HARTZELL PROPELLER INC.
SERVICE BULLETIN
HC-SB-61-327

Propeller - Inspection of D-4511(L)(P) Spinner

Figure 1

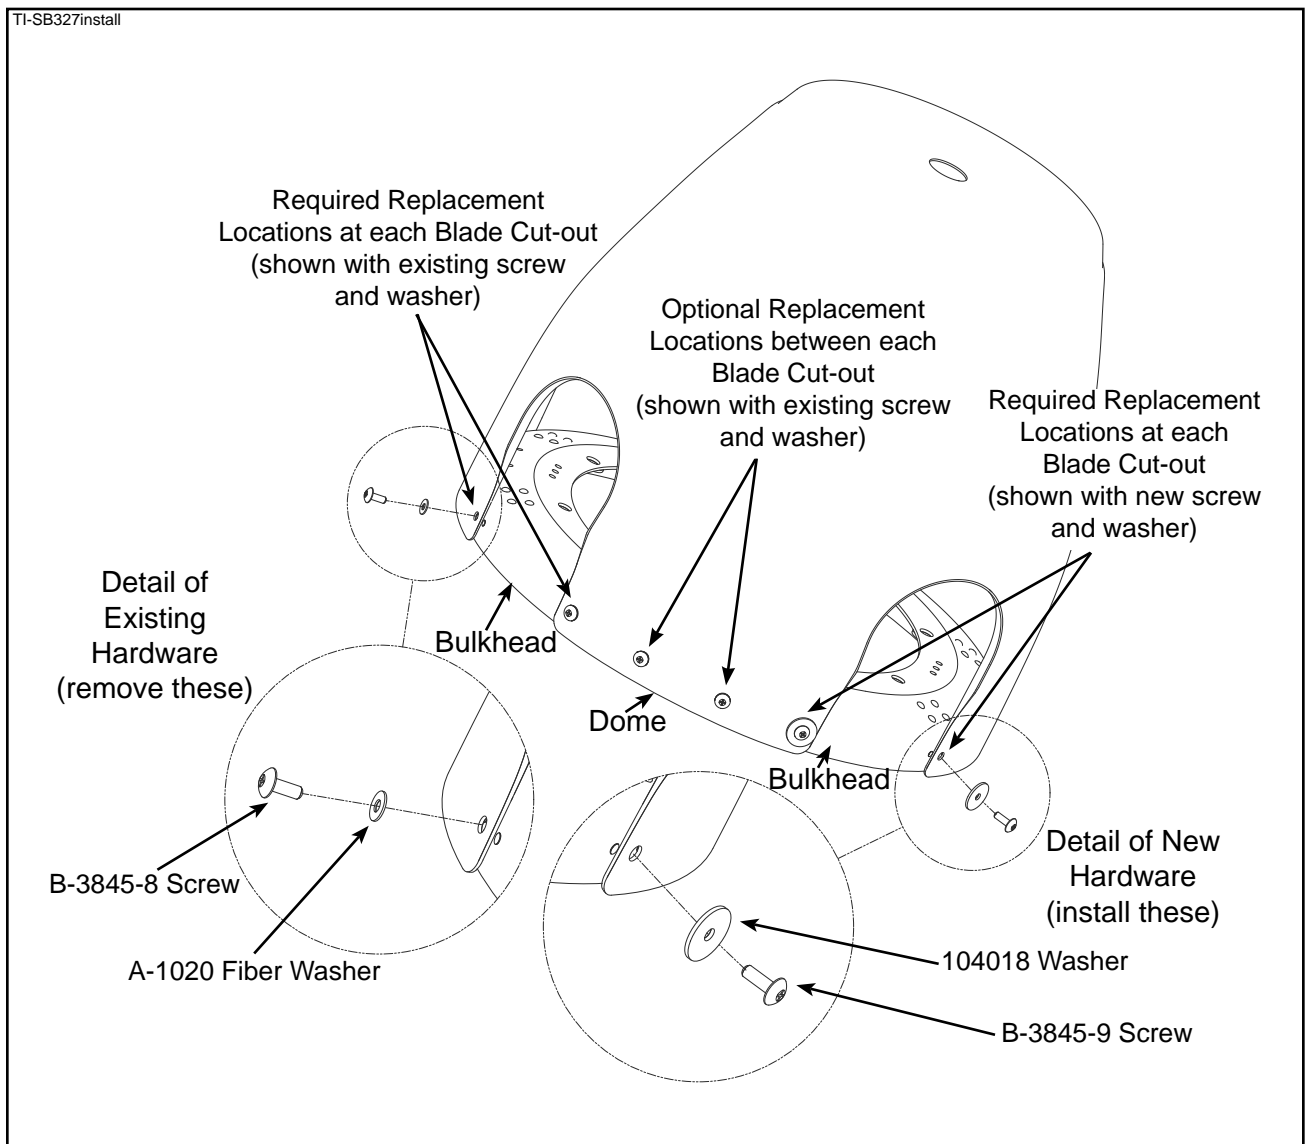
- (e) Using eight (8) of the 104018 washers and eight (8) of the B-3845-9 screws in the locations identified in Figure 1, as an alternative to eight (8) of the removed fiber washers and screws, install the spinner dome in accordance with Hartzell Owner's Manual 115N (61-00-15).
 - 1 Replacement of the washers and screws in only the eight (8) locations identified in Figure 1 are required for Terminating Action of this Service Bulletin.
 - 2 At the discretion of the owner/operator, all 16 removed fiber washers and screws may be replaced with the 104018 washer and the B-3845-9 screw.
 - 3 After installation is complete, discard all remaining washers and screws.
